ENVIRONMENTAL PROTECTION AGENCY

Approval and Promulgation of Implementation Plans; North Dakota; Regional Haze State Implementation Plan; Federal Implementation Plan for Interstate Transport of Pollution Affecting Visibility and Regional Haze

ACTION: Final rule.

Figure 1. Coal-Fired Boilers Operating Below 0.17 lb/MMBtu

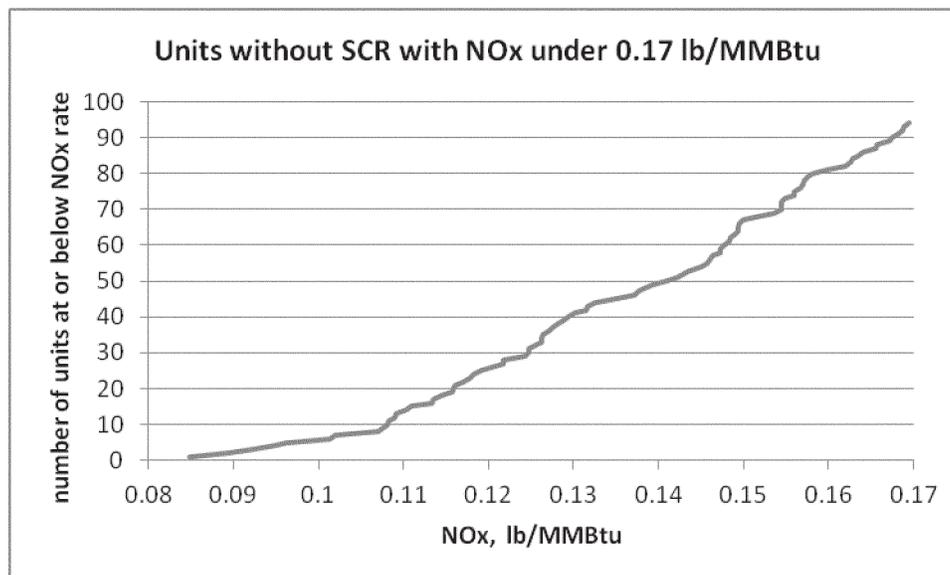
Analysis of emissions data found significant discrepancies in Figures 2.2 and 2.3 of GRE's November 2011 Refined Analysis. A review of EPA Title IV data for 2010 showed 94 coal-fired boilers that do not have SCR achieve annual emissions levels below 0.17 lb/MMBtu, with the median slightly under 0.14 lb/MMBtu (see Figure 1 below). Of these, ten of them are using SNCR in combination with combustion controls to achieve under 0.17 lb/MMBtu. See docket for a list of these facilities. Of these ten, three are supercritical tangentially-fired boilers that use lignite coal with emissions below 0.14 lb/MMBtu. These include Big Brown 1 and Monticello 1 and 2, as discussed earlier in our responses. In addition, the NEEDS Database v.4.10 for the Final Transport Rule in the CSAPR docket includes two tangentially-fired coal/steam units from North Carolina with LNC3 and SNCR that had emission rates of 0.159 lb/MMBtu and 0.164 lb/MMBtu.

As we explain elsewhere, we have decided to revise the BART limit from 0.12 lb/MMBtu to 0.13 lb/MMBtu on a 30-day rolling average.
